# CITY OF ALBUQUERQUE

RE: 417 Headingly Ave, N.E

Grading Plan Stamp Date 3/18/18 Engineer's Certification Date: 4/22/18

**Hydrology File: G14D090**

## 417 HEADINGLY AVE., NW **GRADING PLAN**

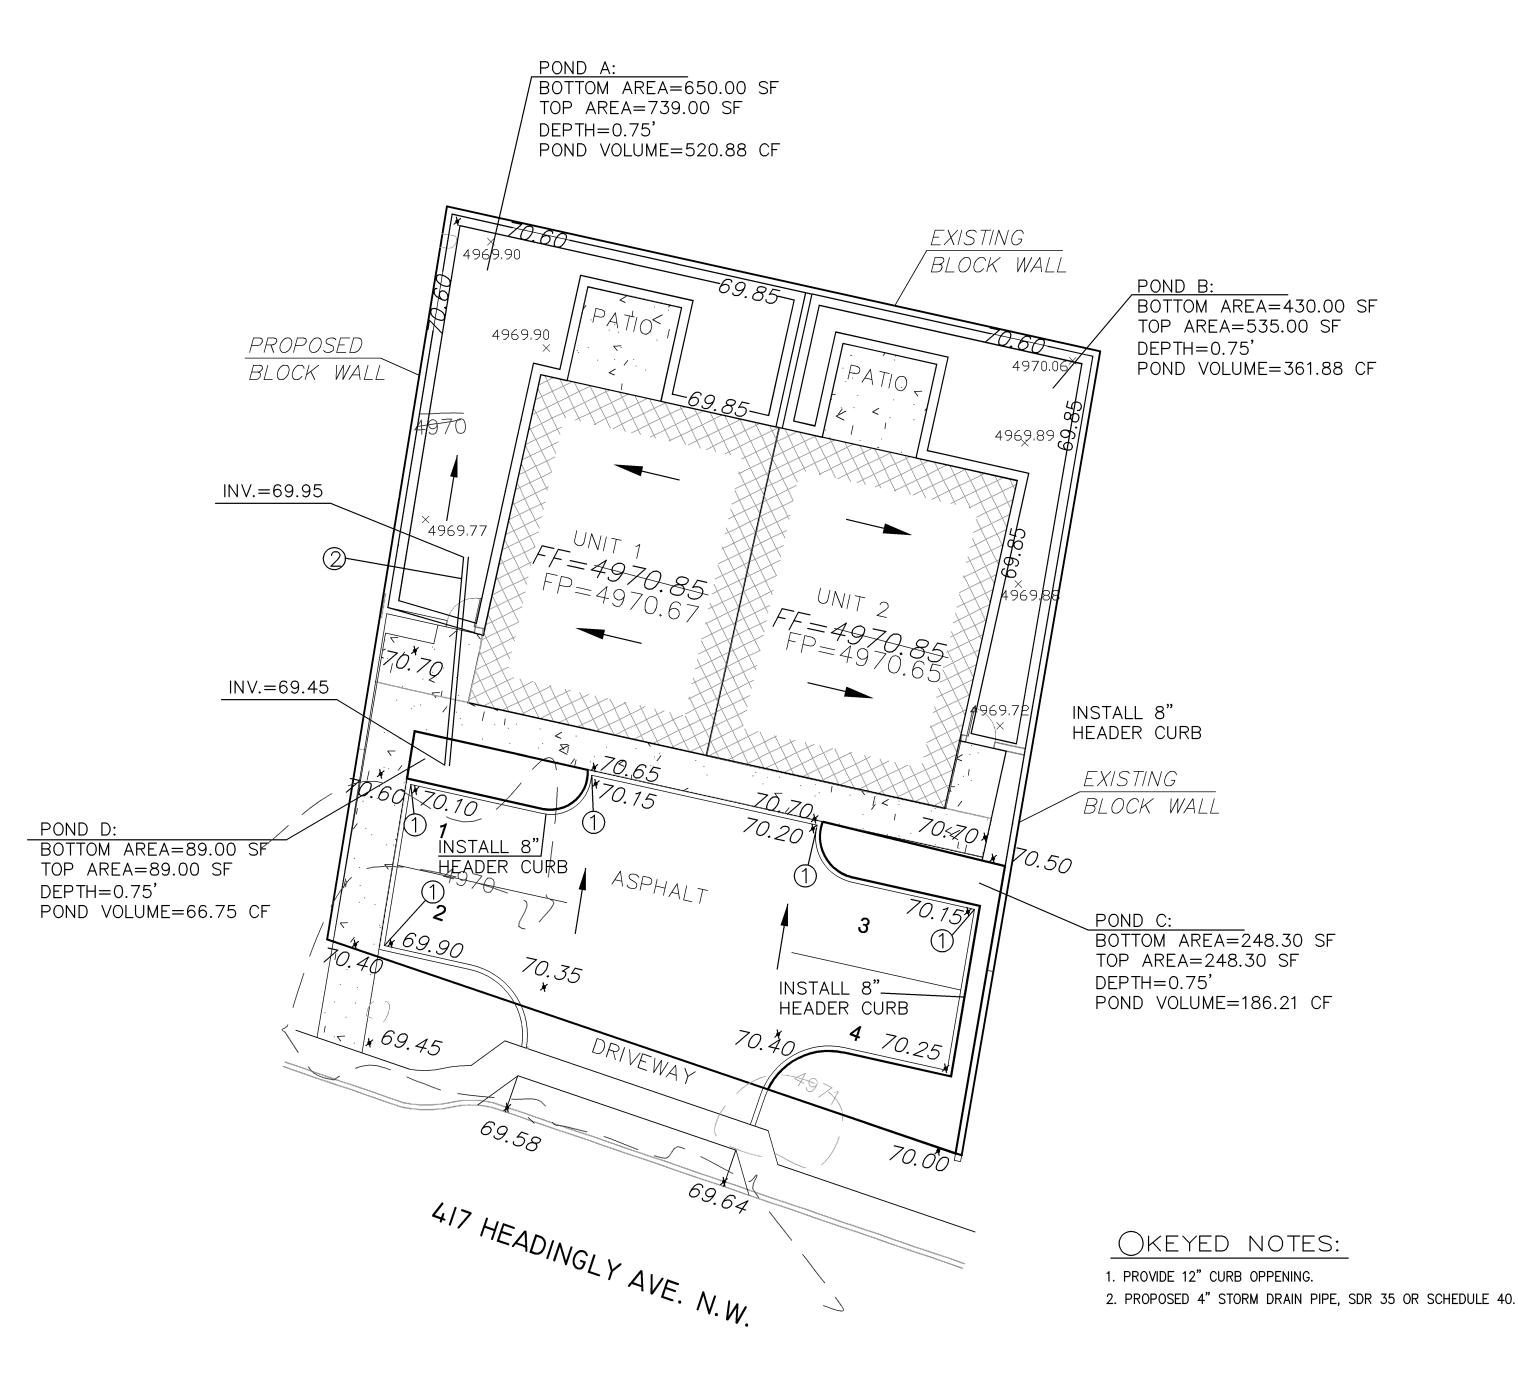
Based on the information provided in your submittal received 4/24/18, the engineer's certification is approved for Building Permit.

1. Engineer's Certification, per the DPM Checklist, will be required to ensure the ponds remained intact following home construction.

2. The Private Facility Drainage Covenant must be recorded with Bernalillo County and a copy included with the drainage certification.
